ADDENDUM #2

PROJECT: Frisco Park
418 S Avalon St.
West Memphis, AR 72301

DATE: 09-06-2019

JOB NO.: HAPC #597

GRADING AND DRAINAGE
C2.1

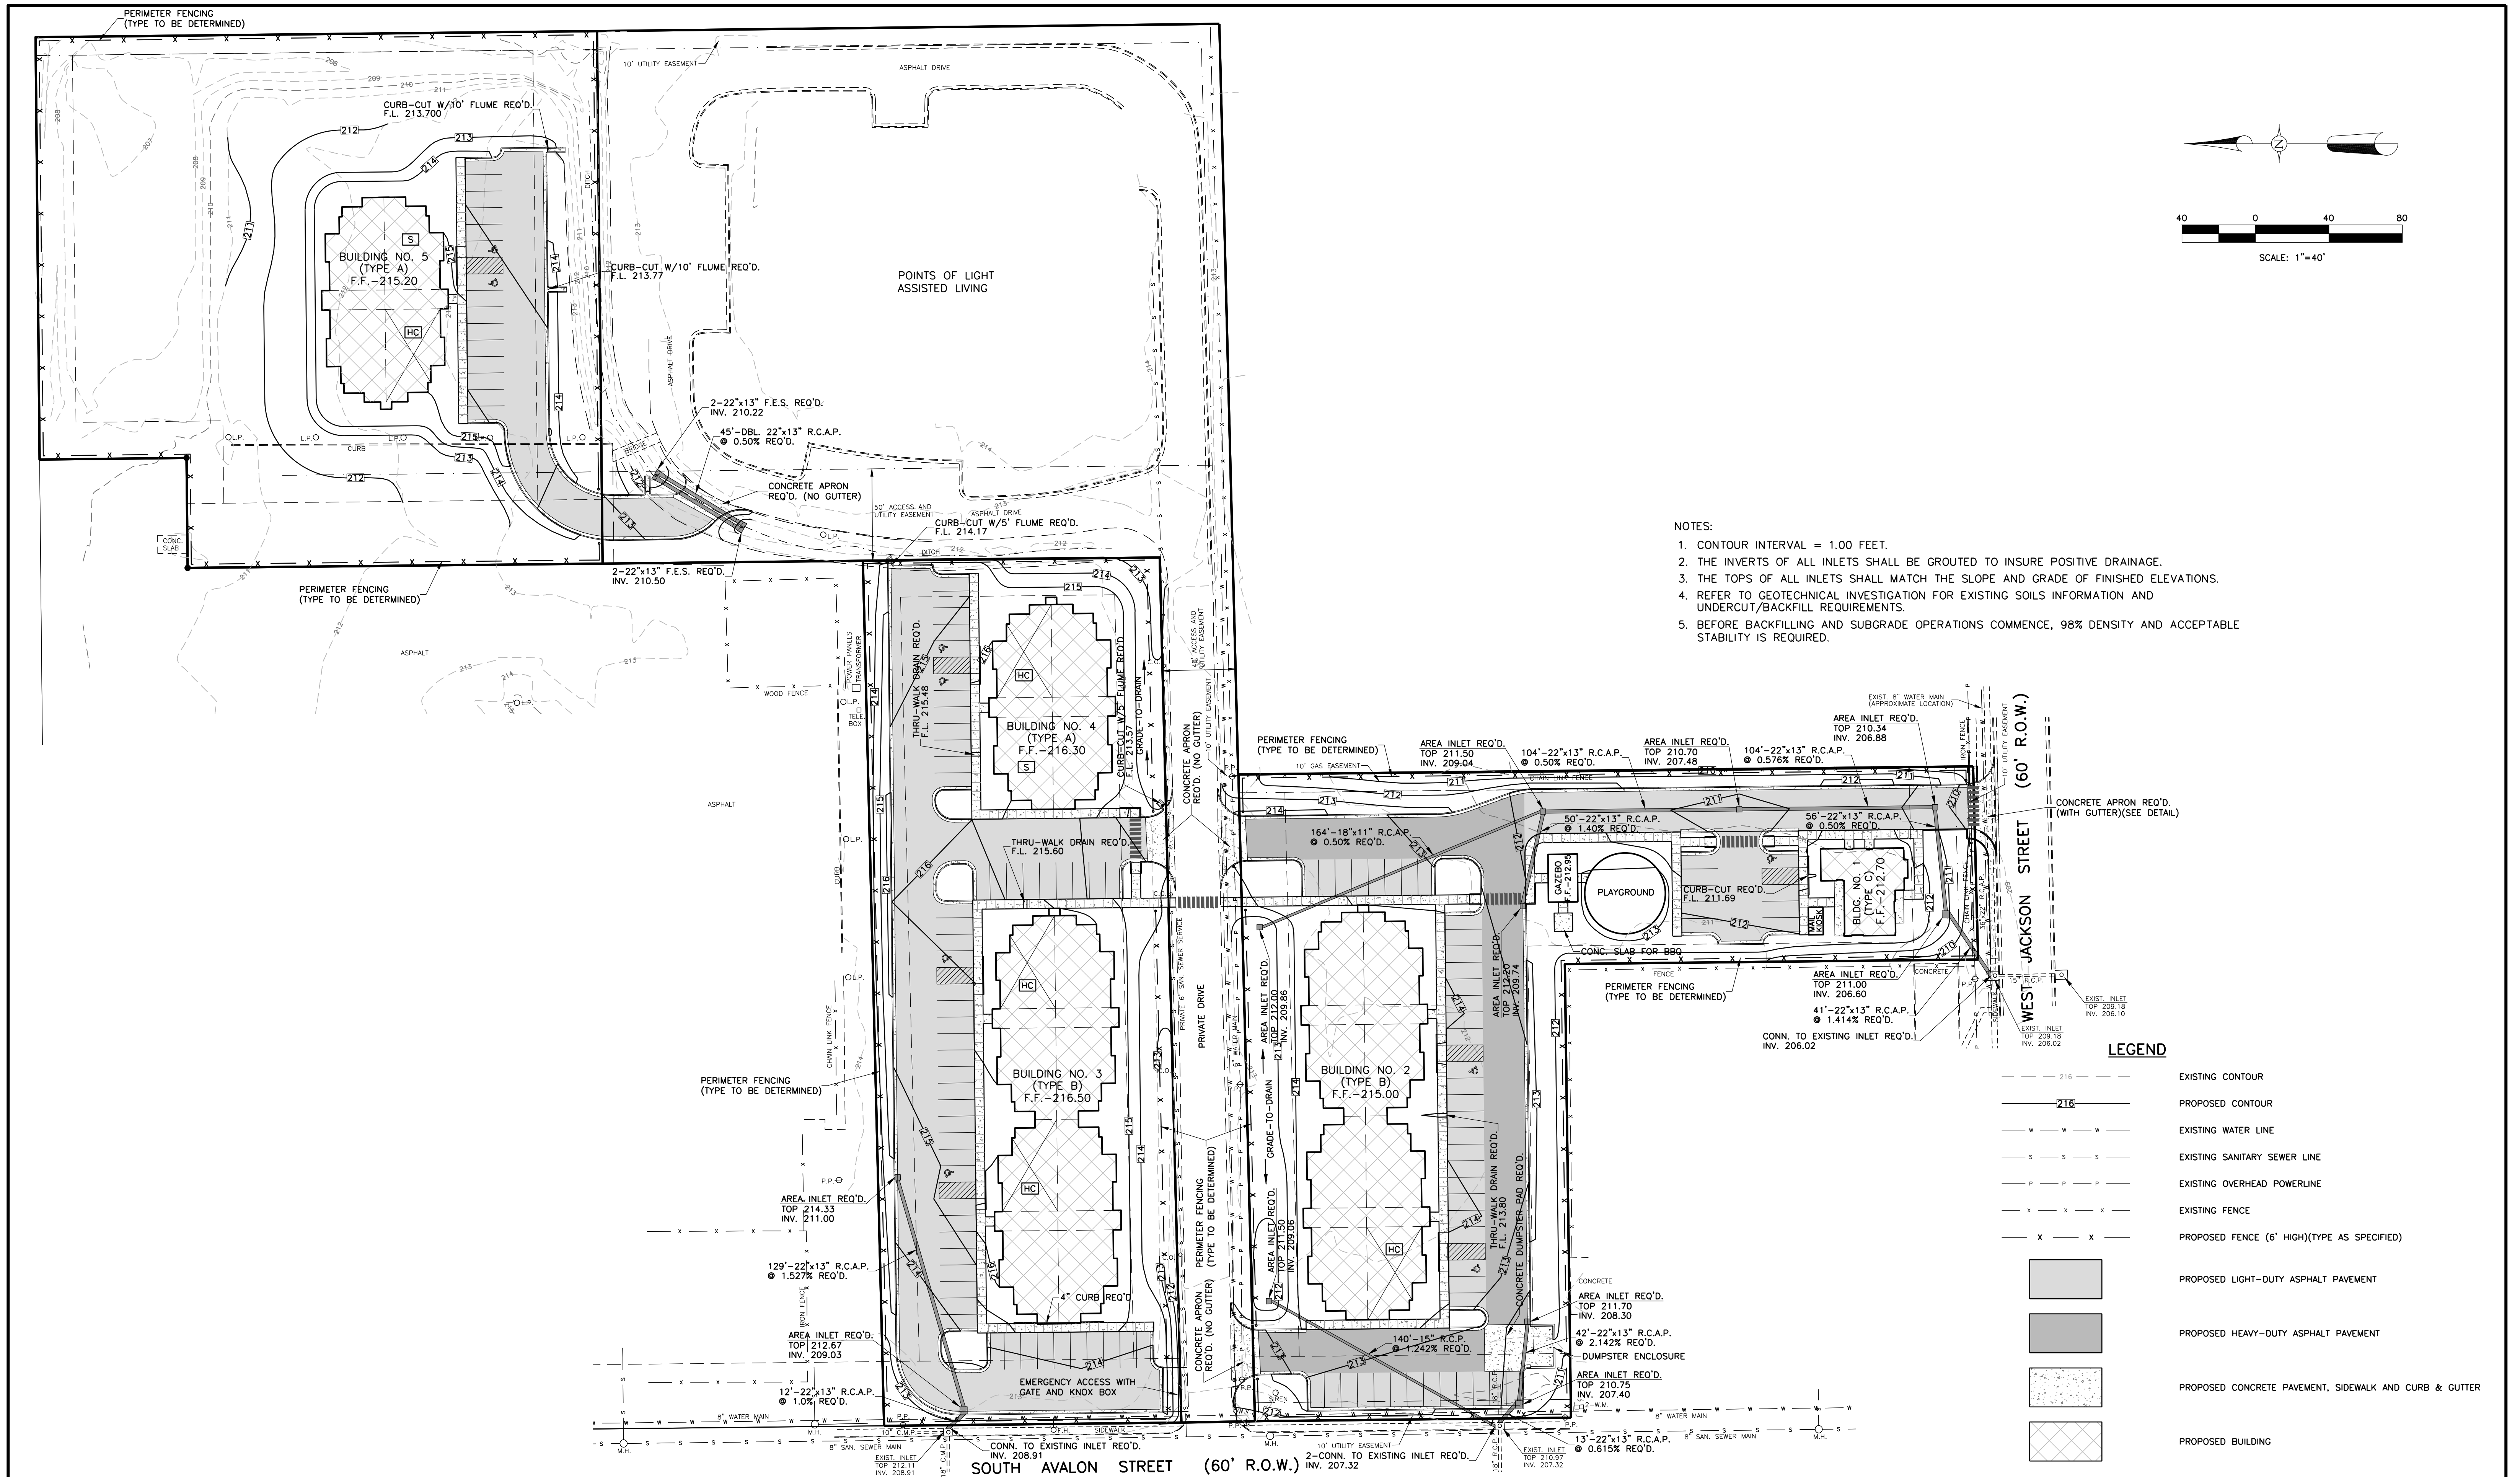
Civil: Sheet C2.1 is re-issued with grading plan.
